February 1, 2018

ADDENDUM NO. 3

**CDBG FUNDED DOWNTOWN INVESTOR-OWNED REHABILITATION AT
159 W. MICHIGAN AVENUE. SECOND FLOOR RESIDENTIAL APARTMENT
BUILDOUT ONLY**

checked by	date
JLR	1/22/18
drawing number	MI
project path	17109
sheet number	1 of 1

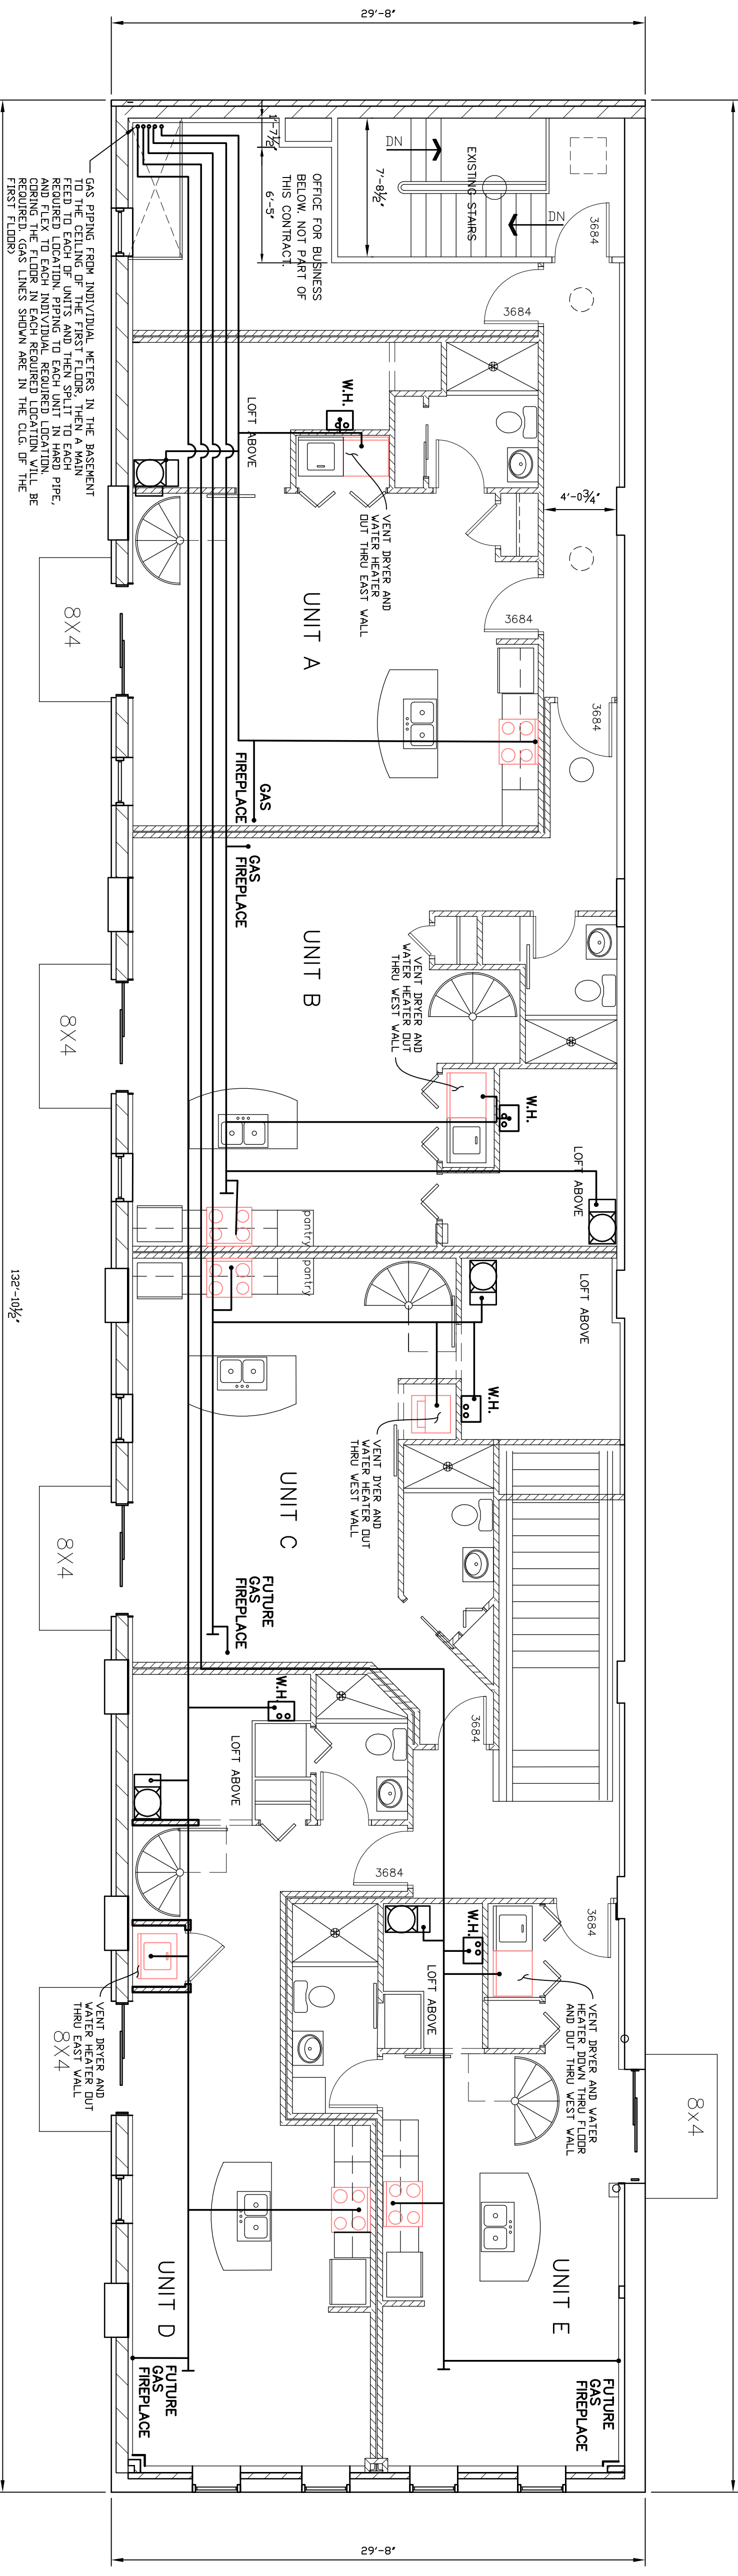
1. All exposed wiring to be in EMT conduit and painted.
2. All wiring inside the walls shall be copper conductors as permitted by code.
3. Revised Sheet E1 is attached showing the location of the combination smoke/carbon monoxide detectors.
4. Revised Sheet A4 is attached showing the main supply duct reduced to a 12" diameter round spiral duct.
5. Revised Sheet M1 is attached showing the main supply duct reduced to a 12" diameter round spiral duct and the location of the interior units of the mini-split system. The location of the roof top condensing units, shown on Sheet A5, can remain the same or be relocated for a more efficient use. The curbs and roof penetrations remain the responsibility of the owner.
6. The following or equal for doors and hardware:

Ductwork & Split sys revisions	MWZ	1/30/18	revised in accordance with construction records by _____ date _____
sewer permit number	_____	water permit number	_____
approved by	_____	name	_____
_____	_____	date	_____
